City of Biddeford
Planning Board
April 07, 2021 6:00 PM Zoom: Apr 7, 2021 06:00 PM Eastern Time (US and Canada)
Topic: Planning Board Meeting

5. **UNFINISHED BUSINESS**
 - 5.A. 2020.11 Site Plan Review for Westfield, Inc. to create multiple office/storage/commercial spaces at 20 Pomerleau Street (Tax Map 2, Lot 81) in the I-3 zone.

PLANNING BOARD
REPORT

3. Engineering Plan set entitled: *4 Unit Warehouse Facility, Pomerleau Street, Biddeford, Maine. REV. Date 3/30/2021*. Prepared by BHM2 Engineers and Surveyors.

SHEET
1

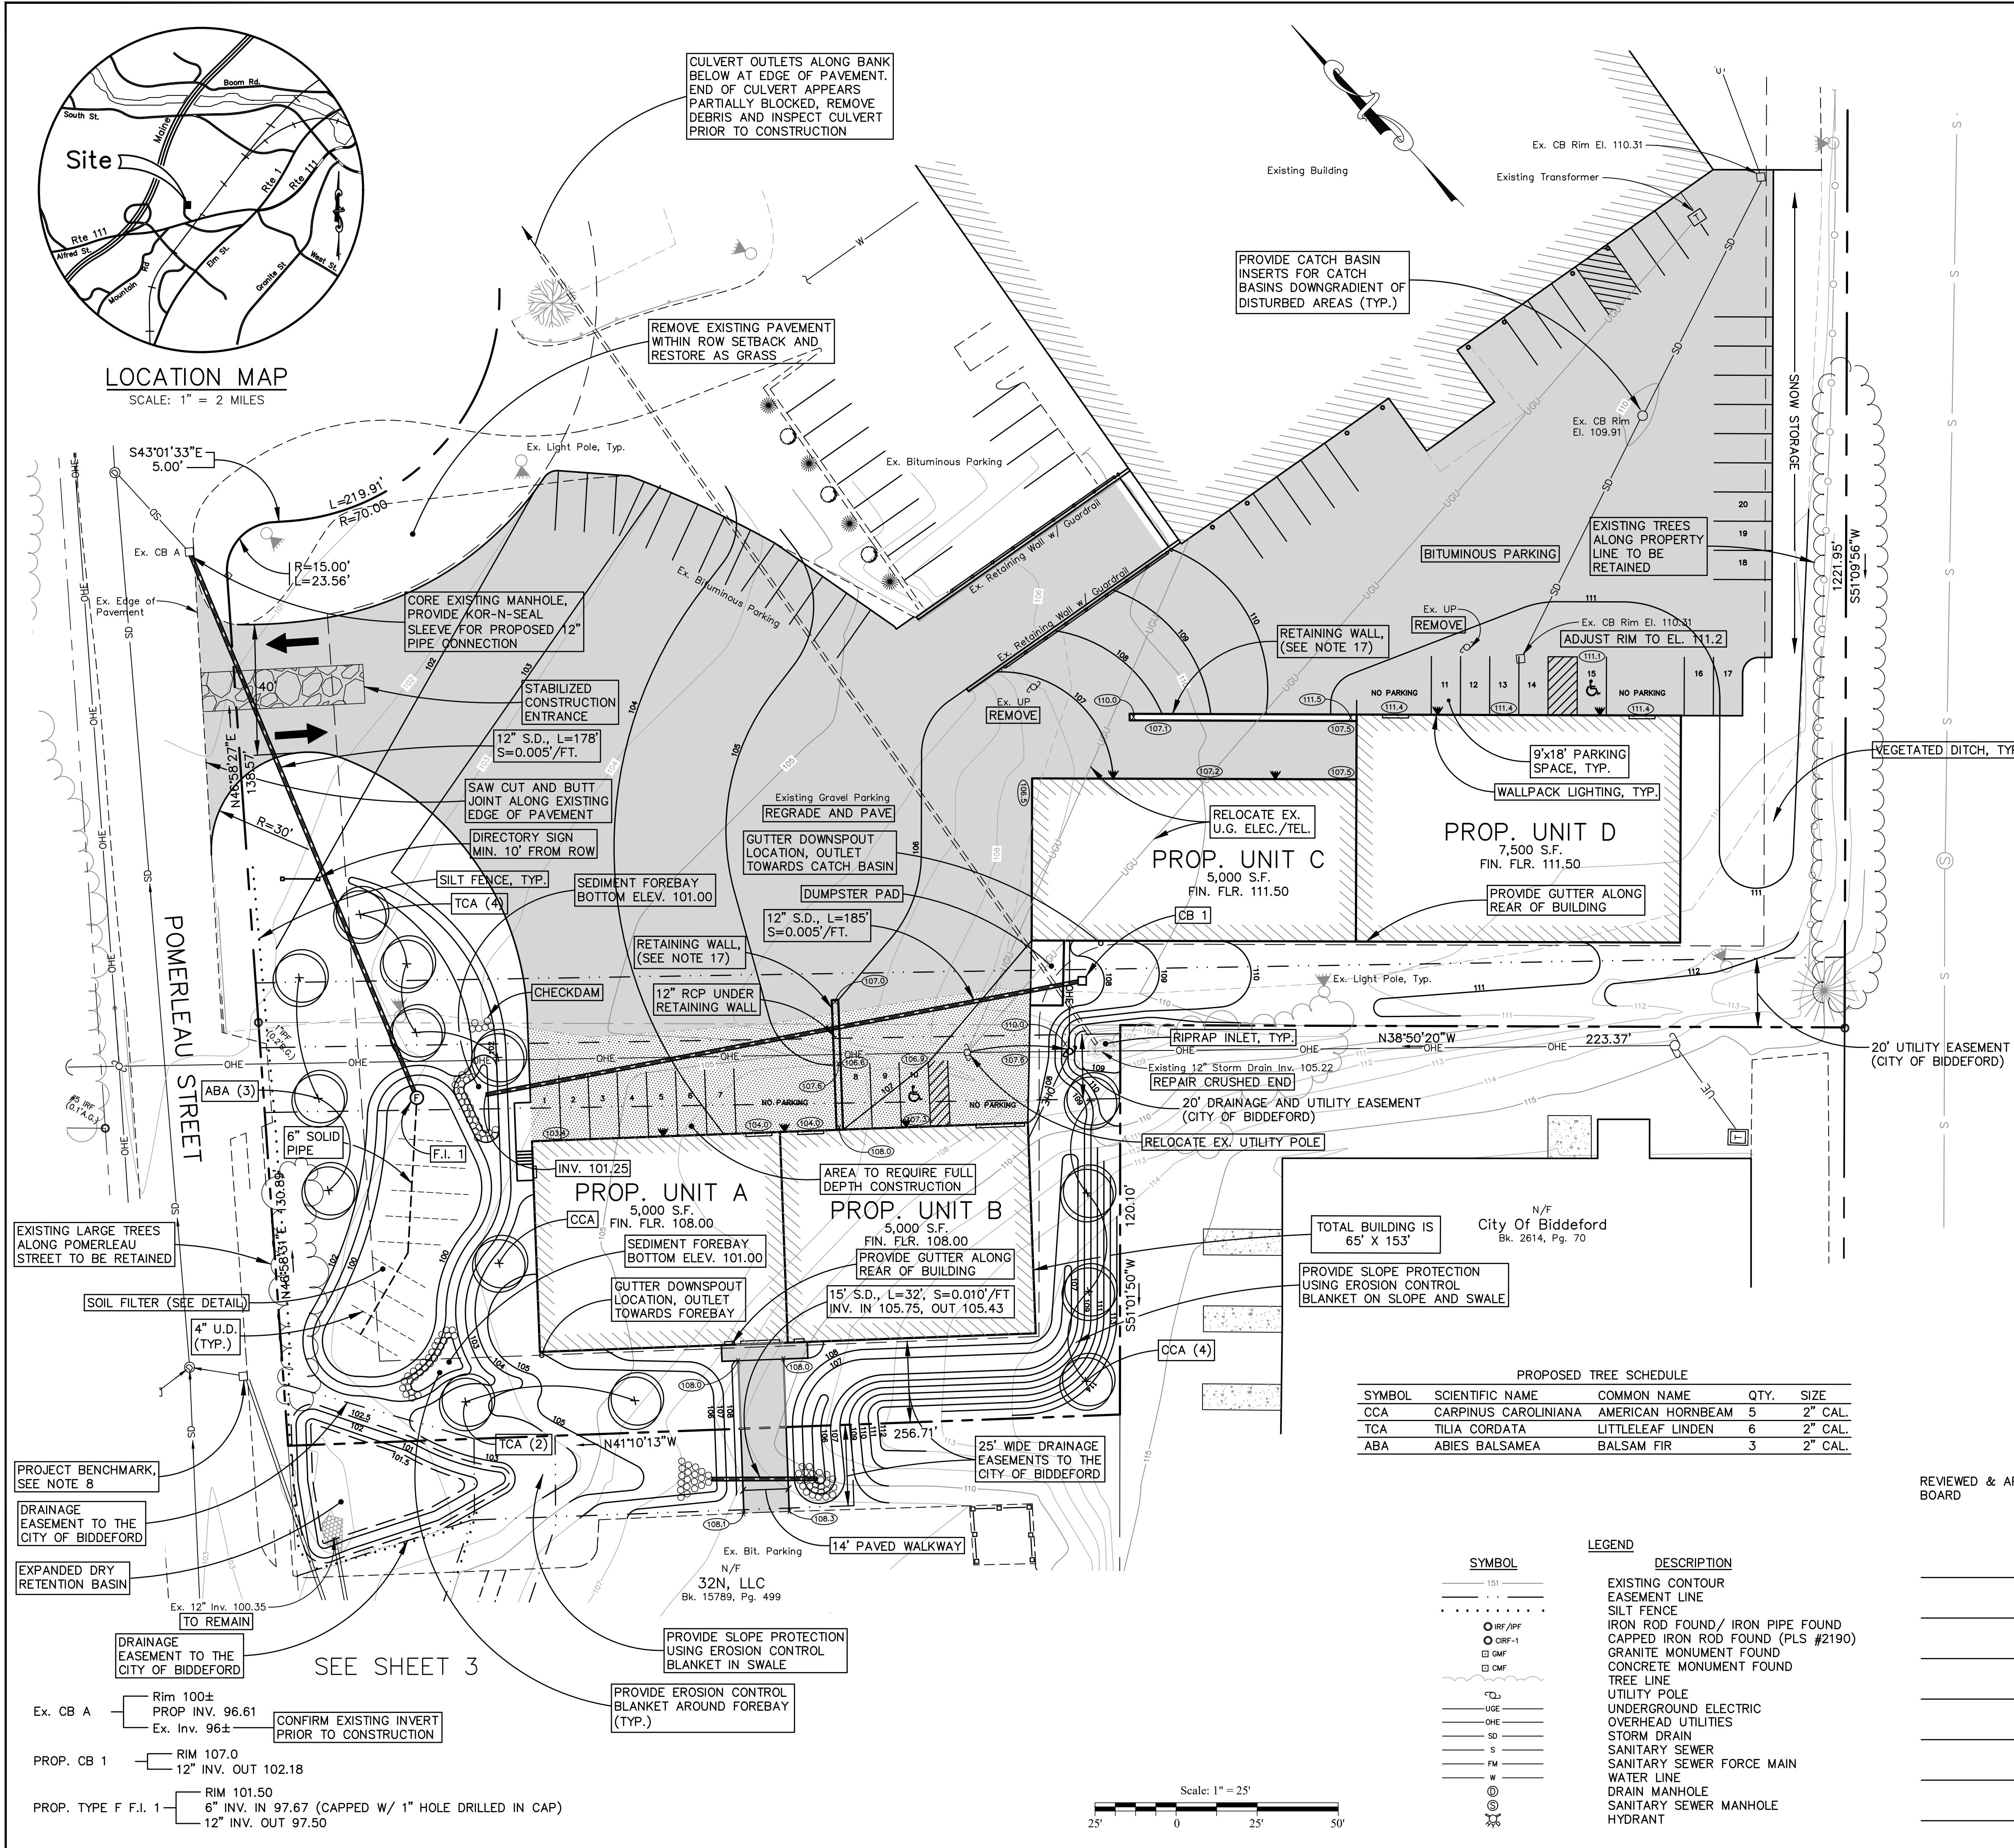
1. Parking Lot Design. As part of the new warehouse buildings, the existing gravel parking lot is planned to be paved. The applicant and Planning Board should consider having the parking and driveway limits reduced to be conforming with the land use regulations. The existing driveway is approximately 75 feet wide; the standard (Chapter 66 Section 111) is 40 feet wide for Type II-A. The parking spaces and surplus pavement should be removed out of the front yard setback to conform to Article XI Site Plan Standards (Sec. 5.B.4.f.) and Article VI Performance Standards (Sec. 49.A.5). **The applicant has removed the proposed pavement from the front yard setback and has reduced the previously proposed 75-foot driveway width to the conforming 40 feet.**

RESPONSE:
Preliminary grades for the top of wall are now shown. Note 17 on Sheet 1 indicates that the retaining walls will be designed by a Structural Engineer. This information will be part of the building permit process.

Grading of the sediment forebays are shown on the site plan, sheet 1. A berm stone size table is now included on sheet 4.

PRECAST CONCRETE
FIELD INLET/OUTLET
CONTROL STRUCTURE
N.T.S.

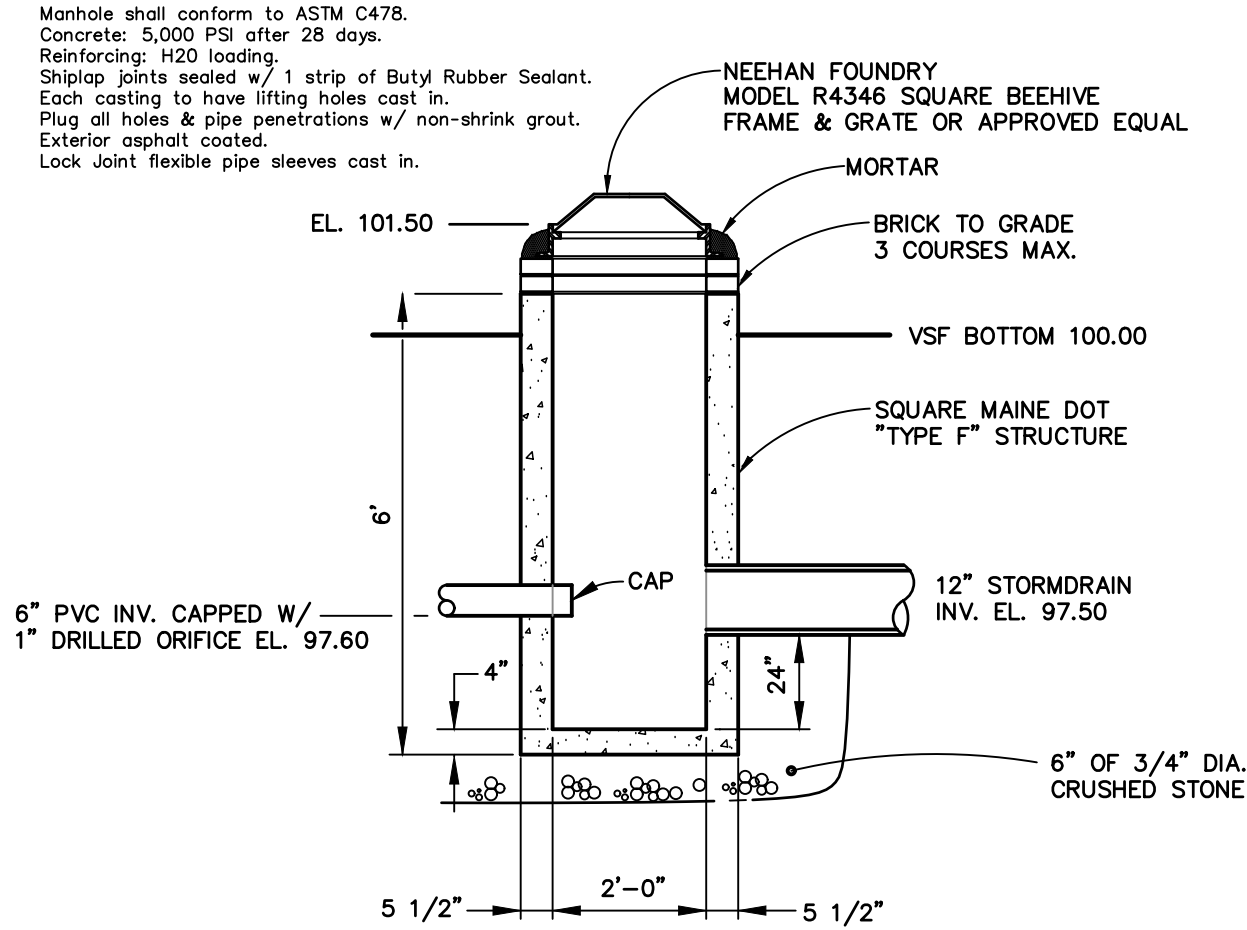
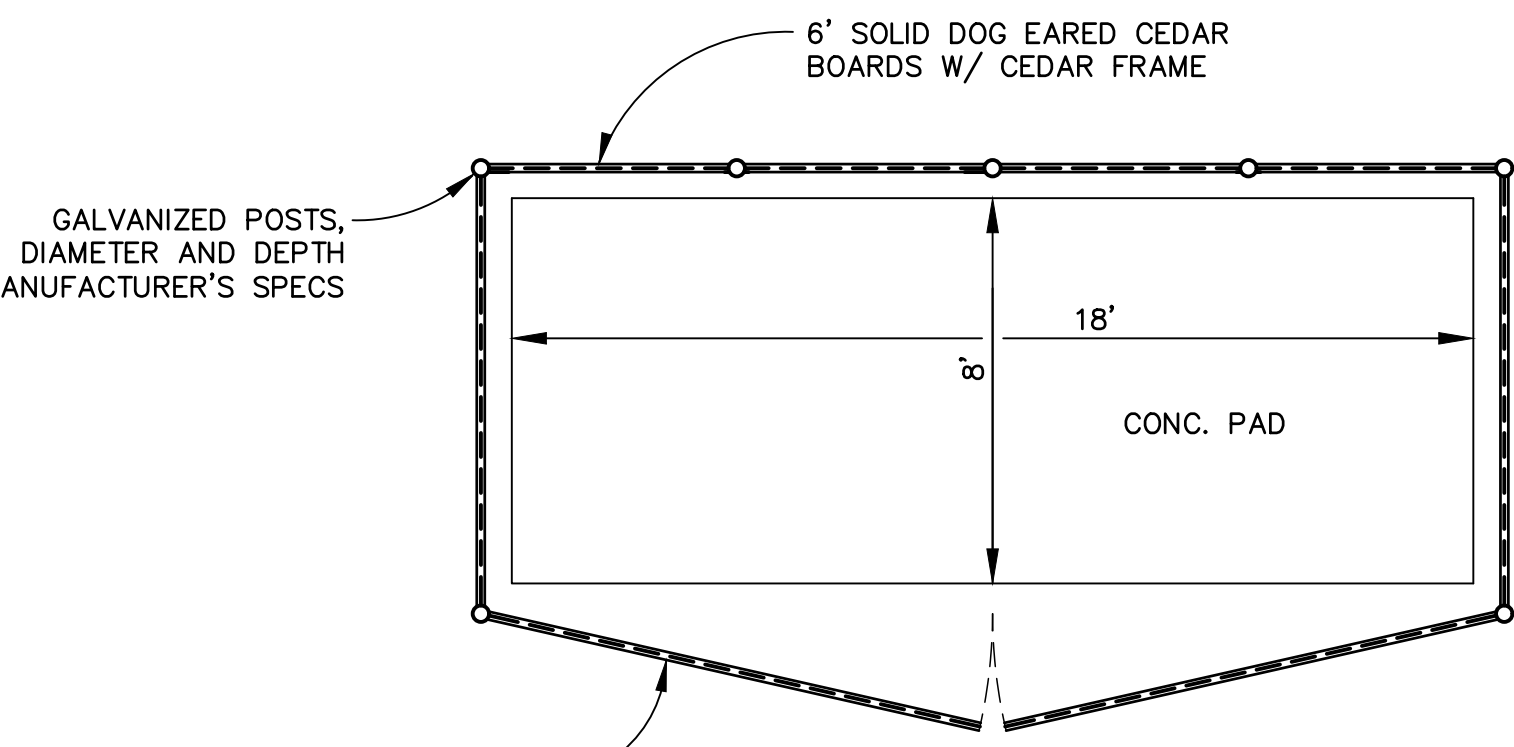
- The outlet structure detail on sheet 4 calls for the rim elevation to be at elevation 102.0 while the model uses 101.6.

- The outlet structure detail on sheet 4 calls for the rim elevation to be at elevation 102.0 while the model uses 101.6.
- The modelling reflects a peak elevation of 101.9 with a berm elevation of 102.0 in SF 1. The grading should be revised to provide 1 ft of freeboard.
- The modelling reflects a peak elevation of 102.5 with a berm elevation of 102.5 in EC 1. The grading should be revised to provide 1 ft of freeboard.
- The modelling reflects a peak elevation of 109.66 at EP 2. A berm should be provided with 1 ft of freeboard to ensure the stormwater remains segregated as designed.
- The 25 year peak runoff rate is expected to increase by 50% at AP #2. What is the impact on the capacity of the storm drain out of the structure? The invert, rim, and pipe size should be determined and the increase in the headwater depth provided.

The GUSF outlet control structure is a square “type-f” catch basin. This is now specified in the detail for the outlet control structure on sheet 4.

A comprehensive set of notes for the underdrained soil filter is now shown on sheet 4. The predicted elevations of stormwater events for the filter are presented in the stormwater calculations found in Appendix D of the stormwater report.

DUMPSTER ENCLOSURE
N.T.S.

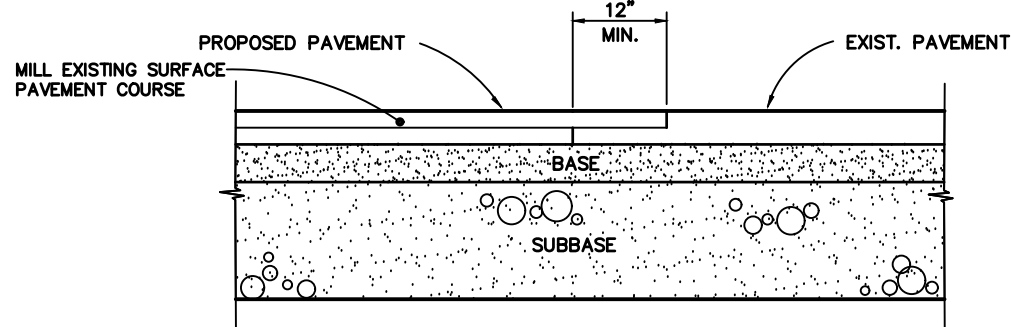
7. Solid Waste. It is not evident from the plan the location of existing of proposed dumpster. The applicant should clarify how solid waste and recycling is planned to be managed and confirm that there is a private hauler that services the site. Plan has been revised to include a location to accommodate a dumpster. The label should be revised to include 'enclosure' has detailed on sheet 4.
